CRITICAL INSTRUCTIONS

Application: Mercedes Sprinter

Part Number:
10009880036/
10009880036E
10009880074/
10009880074E

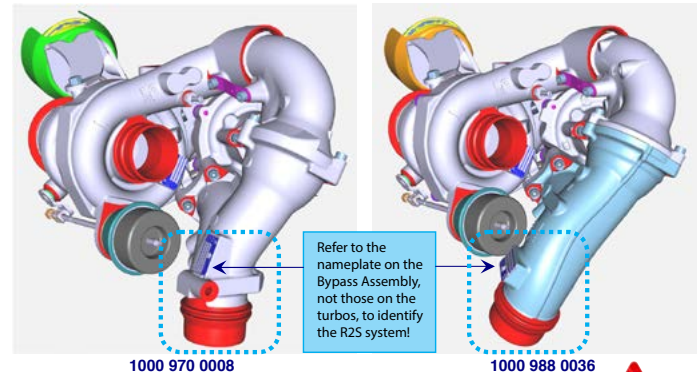
When replacing a 10009880008/10009880008E (In production between September 2008 and December 2010, fitted up to engine 30468350) with a 10009880036/10009880074, additional components are required which need to be sourced directly from the Main Dealer:

This is due to a geometrical difference between the two products and without the additional products, the replacement turbo will not be able to be fitted.

Charge air pipe A 906 528 5082 or -5182*

Coolant pipe A 906 501 1482

Support A 651 096 2940

Support A 651 096 3040

Screw (3x) N 910143 006001

*Use -5182 if vehicle has optional equipment codes H08, N63 or HK4
